Internal Memo

To:	Adrian Ramage
From:	Jenny Grimmatt
Subject:	RC6818 - Minor amendment under Condition 1 to Enable Minor Boundary Adjustment

Resource consent for subdivision and land use (PCC Reference: RC6818 - SL0001/15) was granted on 6 March 2015 to Pikarere Farm Limited approving the creation of five rural-residential allotments in two stages, and the future construction of dwellings on those allotments at 320-380 Pikarere Street, Colonial Knob (being Lots 1-3 DP 63408, Lot 3 DP 373530 & Lot 7 DP 373530). Stage 1 is to be completed within five years of the issue of the consent and Stage 2 within 10 years of the issue of consent.

DEVELOPMENT PLAN
RURAL RESIDENTIAL SUBDIVISION
AND BOUNDARY ADJUSTMENT

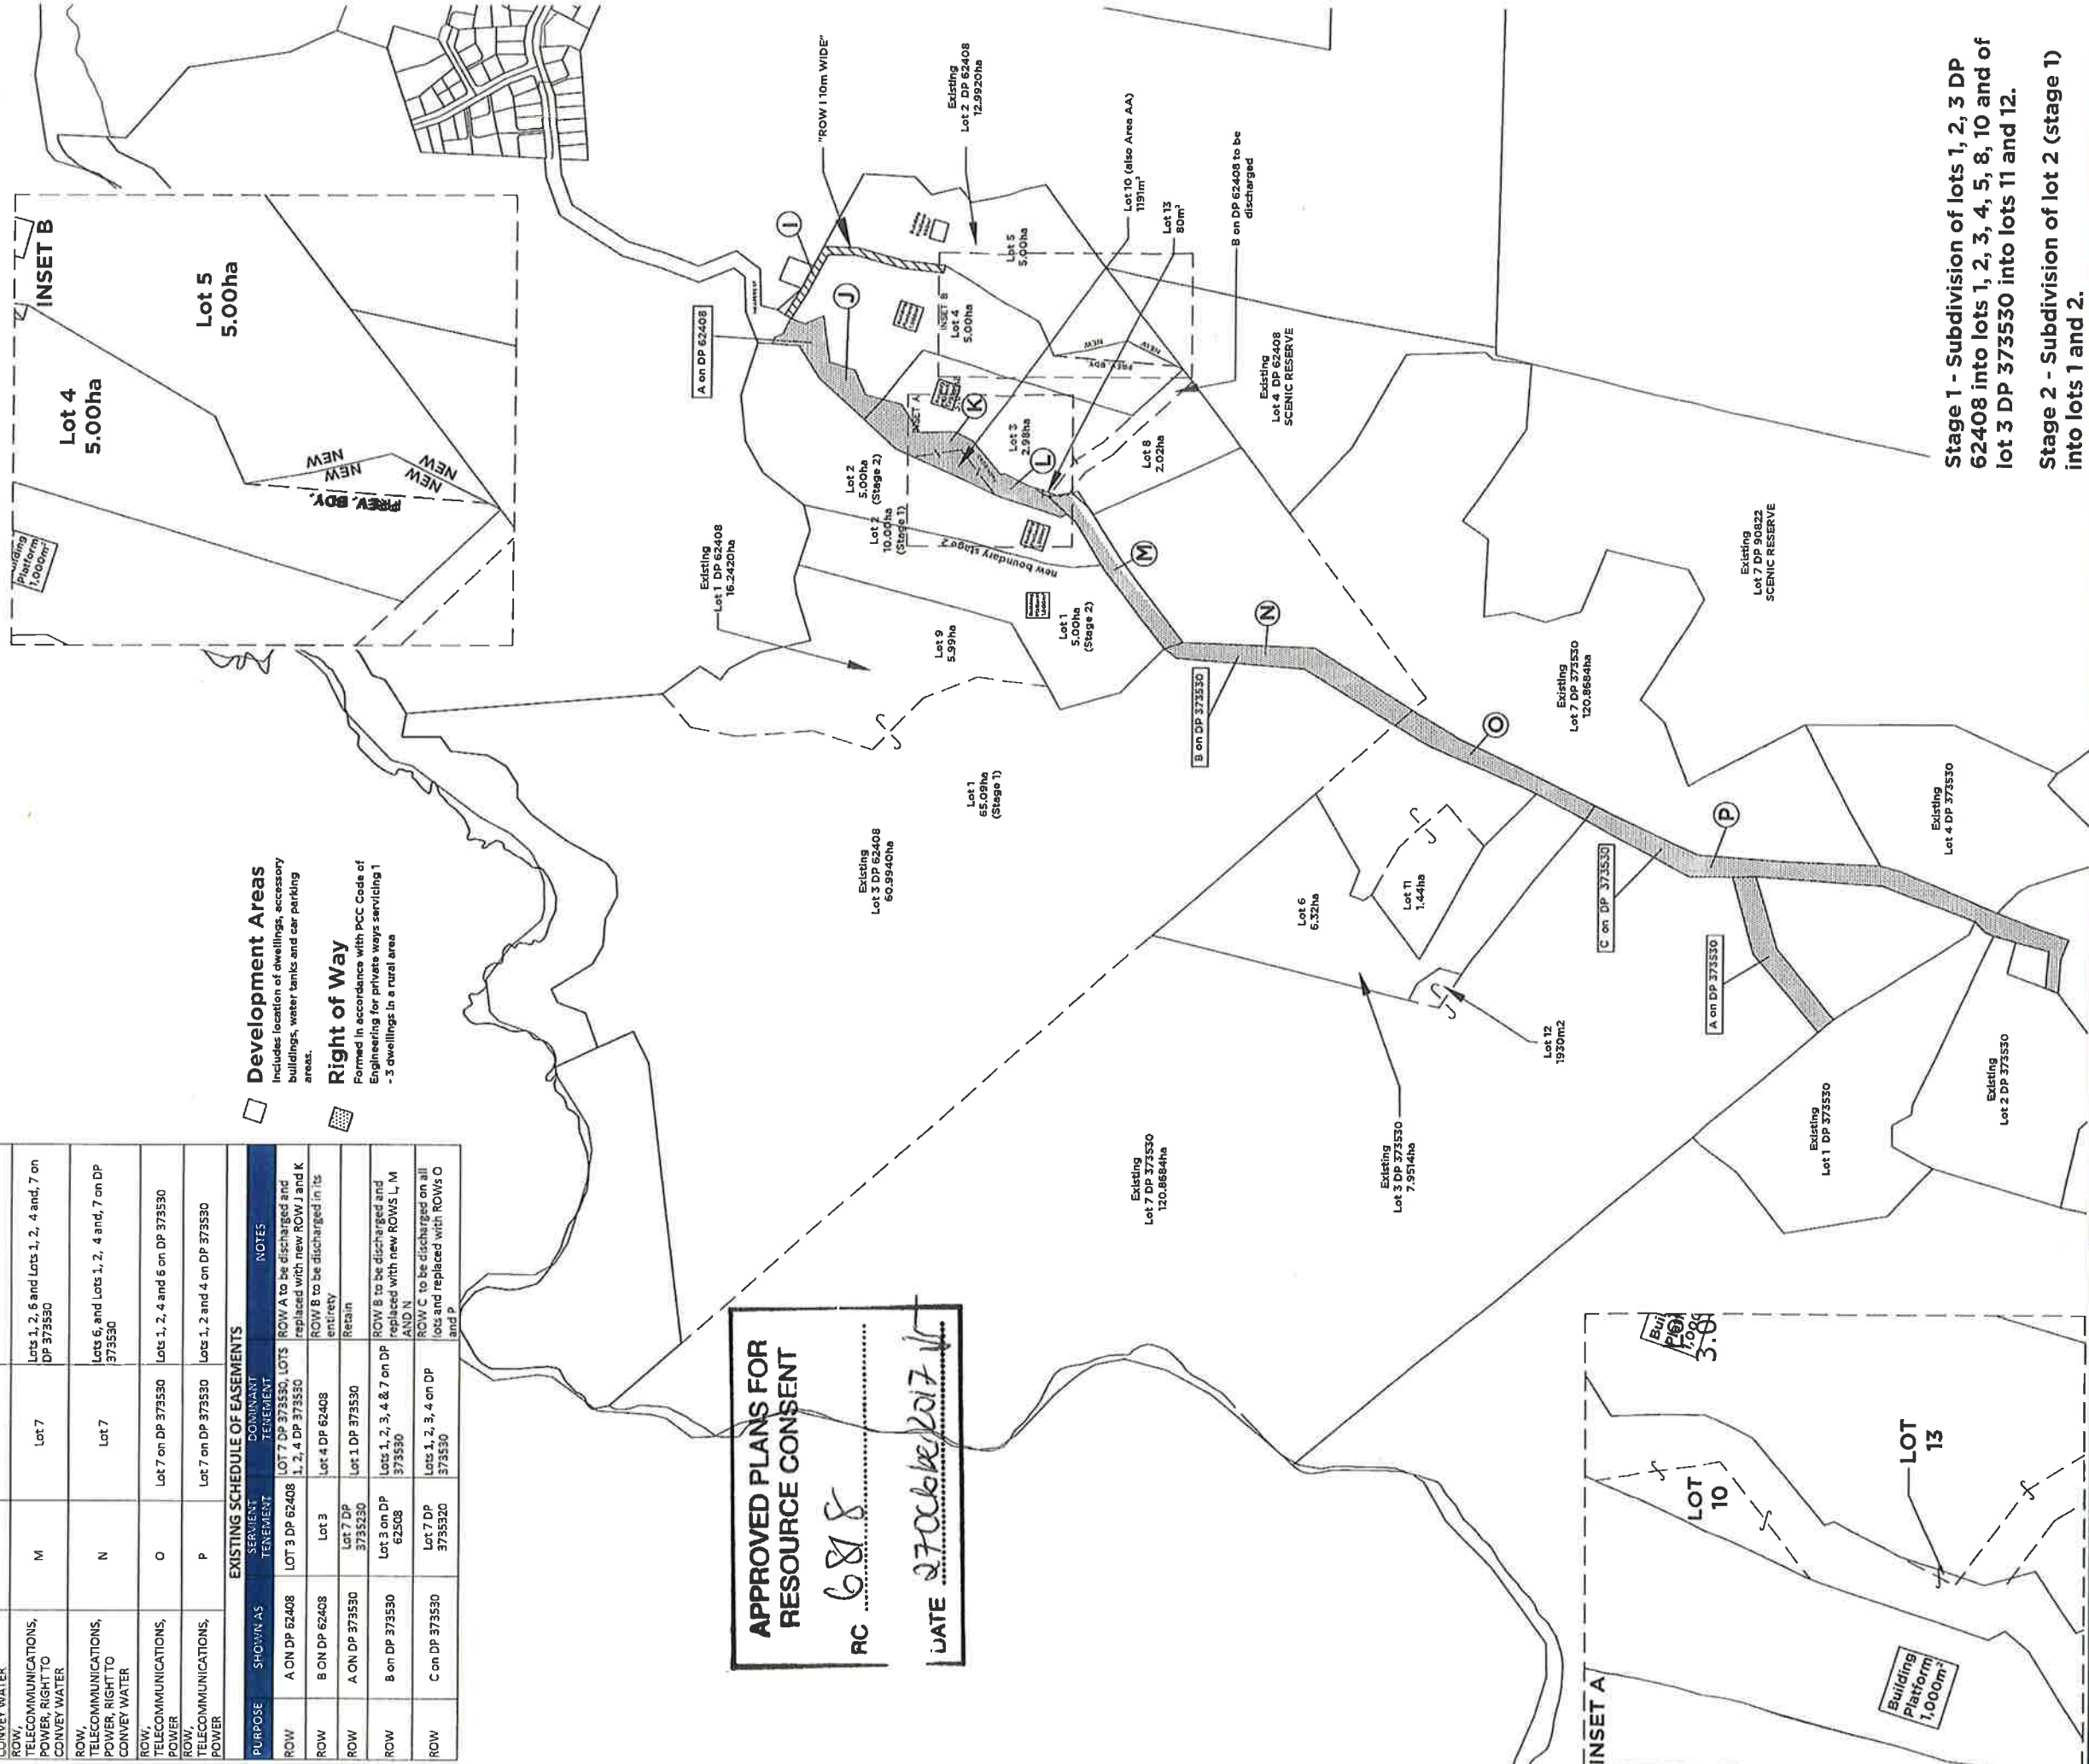
The landowner/consent holder has recently identified that a small stock dam, shown on the approved Scheme Plan as being mainly within Lot 5, should be within Lot 4. A minor amendment under Condition 1 of Resource Consent RC6818 has therefore been requested¹ to reflect a revised scheme plan showing a revised internal boundary between Lots 4 and 5 so that the stock dam is entirely within Lot 4. The applicant also requests confirmation that the proposal is "in general accordance" (IGA) with the existing resource consent.

The revised proposal (a minor boundary adjustment between Lots 4 and 5) is shown on the plans prepared by LandMatters, titled and numbered as follows:

The new plan titles include the same references to stages and lots as the references on the originally approved plans, but have updated drawing numbers and dates and the text “Lodged as “IGA” by Applicant” has been added to the plan face.

I therefore consider that the proposed minor boundary adjustment between Lots 4 and 5 is a practical improvement to the utility of Lots 4 and 5 and will not result in any discernible effects on the environment compared with the originally approved scheme plan.

That the alteration to the boundary between Lots 4 and 5 as shown on the plans prepared by LandMatters, titled and numbered as follows:

DATE: 22/7/16 PROJECT NO: J271
SCALE: 1:4,000 @ A1
1:8,000 @ A3
DRAWING NO: REV DP PIK1 - 06

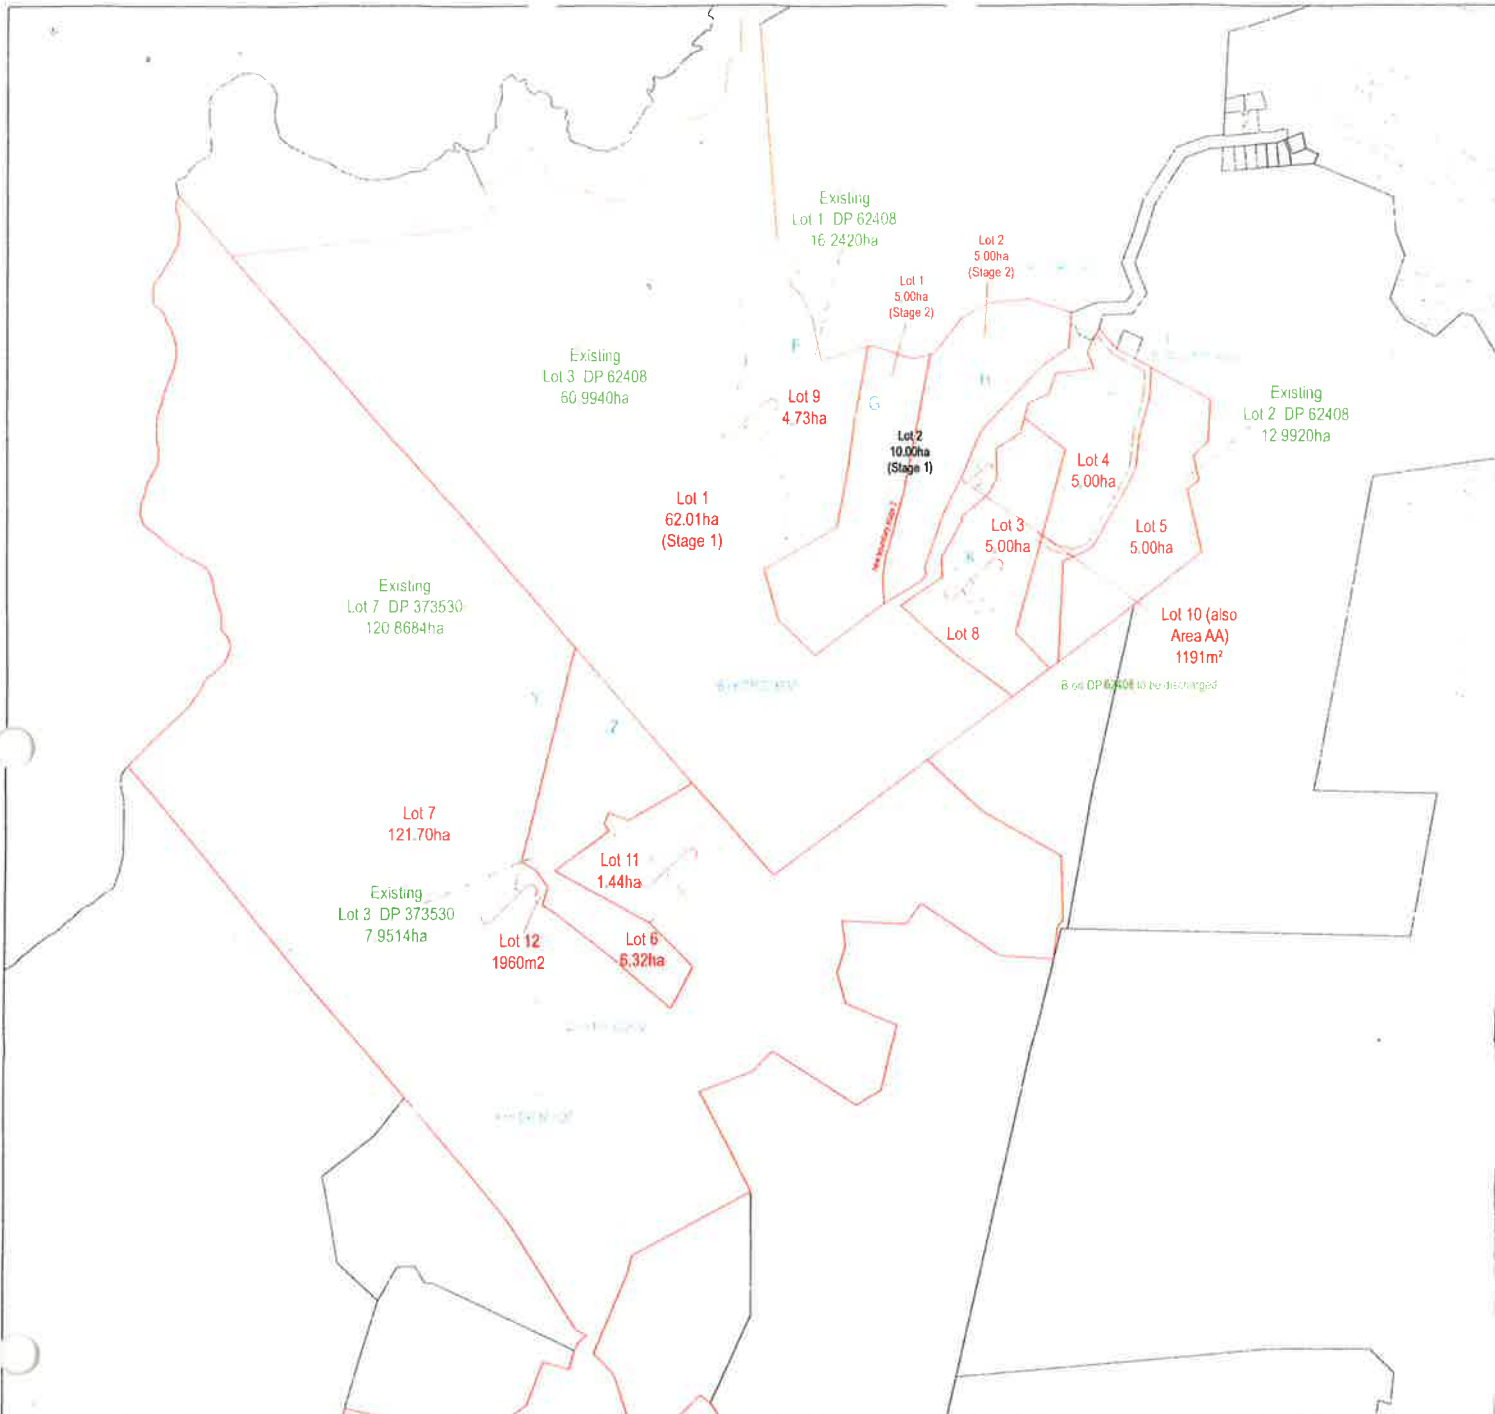
8. Prior to approval under Section 223 of the Resource Management Act 1991, the easements specified on the approved scheme plan DP PIK1 Rev 6 shall be created or reserved for the purpose specified and endorsed in a memorandum on the Land Transfer Plan.

9. Prior to approval under section 223 of the Resource Management Act 1991 the identified development areas shown on Drawing Number DP PIK1 Rev 6 dated 22/7/16 drawn by Land Matters Property Consultants shall be surveyed and marked on the Land Transfer Plan.

- 25(c). Proposed Right of Ways identified as “I” on Land Matters Plan DP PIK1 Rev 6 shall be formed and drained in accordance with the PCC Code of Land Development and Subdivision 2010, Land Development and Subdivision Infrastructure - NZS 4404: 2010, and Part H of the District Plan.
